(11) EP 2 003 806 A1

(54) Protection of RCL/MAC control messages in reduced latency EGPRS

PARTIAL EUROPEAN SEARCH REPORT

INCOMPLETE SEARCH SHEET C

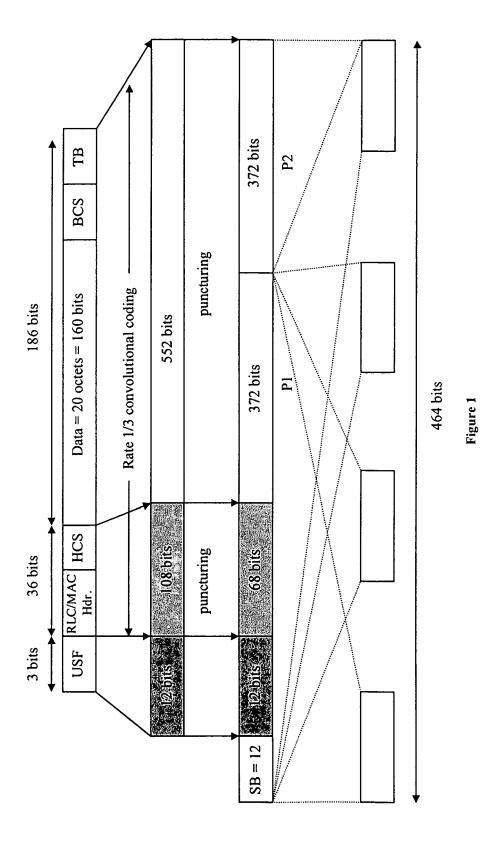
In contrast to the generic formulation of the claim, the description merely offers a very limited disclosure as to what the desired coding scheme effectively looks like. Essentially, two very specific embodiments of the claimed coding scheme are presented, differing in a rate r of a convolutional code applied after appending an 18-bit CRC to 160 bits of control message payload (see page 3, lines 3-10 and figure 1: r=1/3 and lines 19-24: r=1/2 respectively).
